Re: Perinton Reserve (Formally Aldrich Single Family Homes)
Tax ID: 167.13-1-11, 167.13-1-7 & 167.13-1-2.1

Re: Perinton Reserve (Formally Aldrich Single Family Homes)

This letter addresses comments from town staff dated 6/13/25.

SITE DEVELOPMENT PLANS FOR
PERINTON RESERVE
TOWN OF PERINTON, MONROE COUNTY, NEW YORK
P.N. 20254109.0000

STORMWATER MANAGEMENT AREA PROFILE

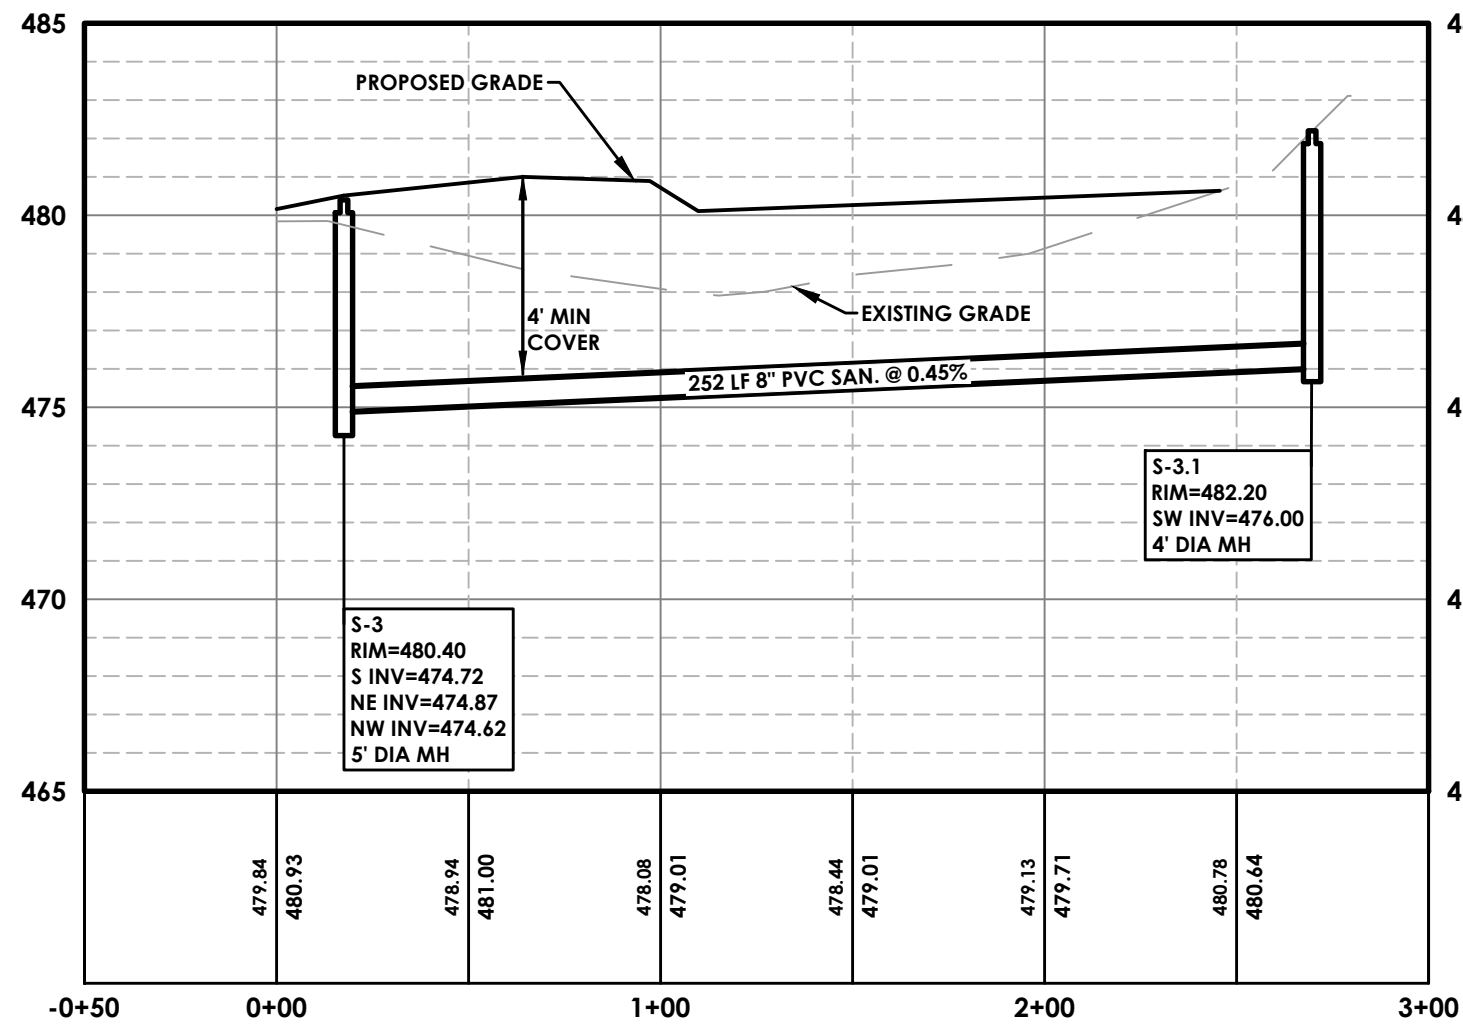
26. Provide a cross section of the SMA with 1, 10 and 100 Year storm elevations shown and spillway and outlet structure and emergency spillway labeled.

Response: A cross section has been added to the profile sheet.

INFILTRATION BASIN OUTLET STRUCTURE

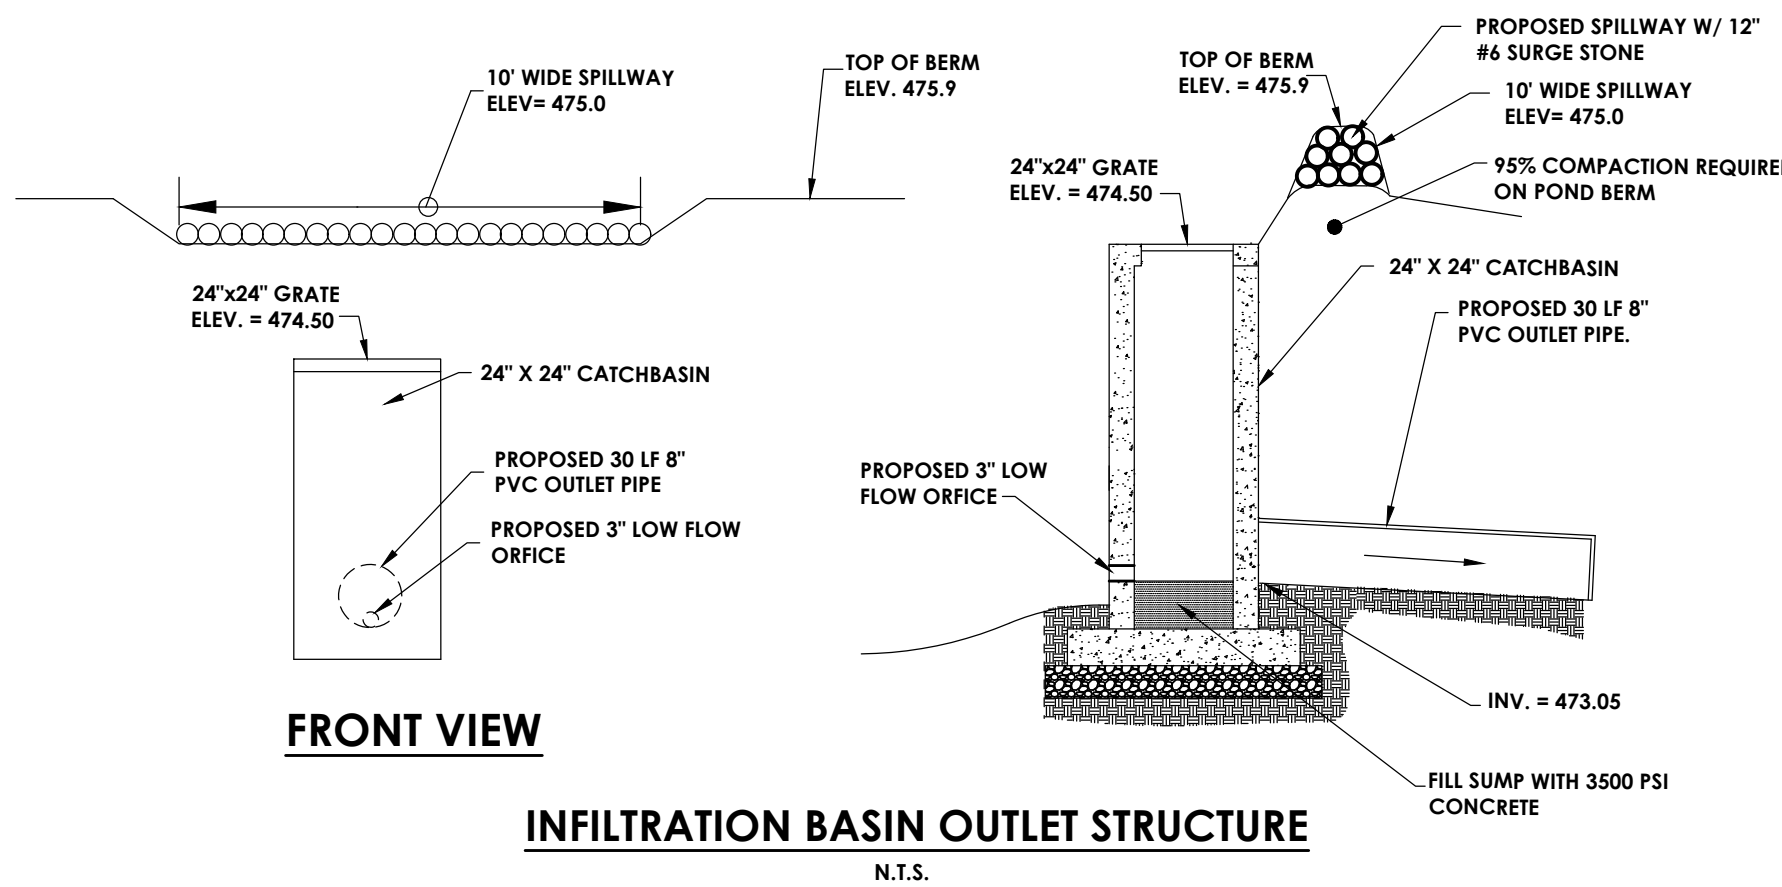
24. Provide a detail showing the proposed outlet control structure with all top of grate, outlet invert and orifice elevations labeled.

Response: A detail of the outlet control structure has been added to Detail Sheet C-203.
